STAFF REPORT
March 2, 2021

AGENDA ITEM: VII-B (File No. SPAR-20013)

Consideration of a Site Plan and Architectural Review application for the construction of a public facility that includes a 7,746 square foot 2-story office building, an approximately 15,000 square foot warehouse, parking for equipment and machinery and on-site storage of materials. The 5.12 acre site is located at 235 South Haskell Street within the General Commercial (GC) zoning district in the Transit Oriented Development (TOD) Corridor and is identified on the Jackson County Assessor's Map as 37S 2W 10AD Tax Lots 700 and 798. **Applicant:** Central Point Parks & Public Works Department; **Agent:** S& B James Construction Management

01 NORTH ELEVATION

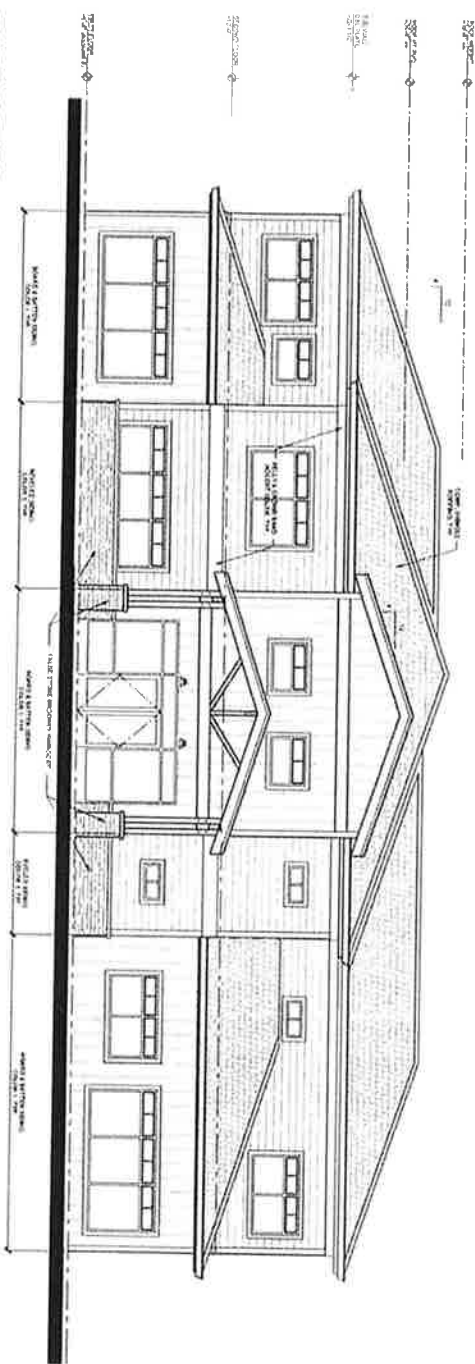
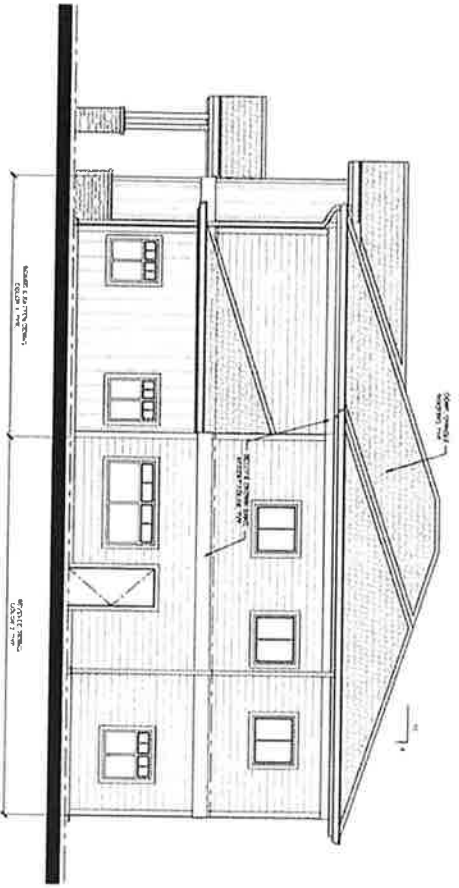
The office building presents a façade to South Haskell Street on the west and a façade to Ash Street on the north. The building design includes an entrance feature that extends approximately 6-feet from the main building wall with a dormer-style roof. The north and west facades provide variations in materials, ample glazing and varied rooflines for variation and

interest in material design. Architecturally, the building complies with the building design standards in CPMC 17.75.042 with changes in vertical and horizontal massing, changes in color, texture and materials (Attachment “A-2”).
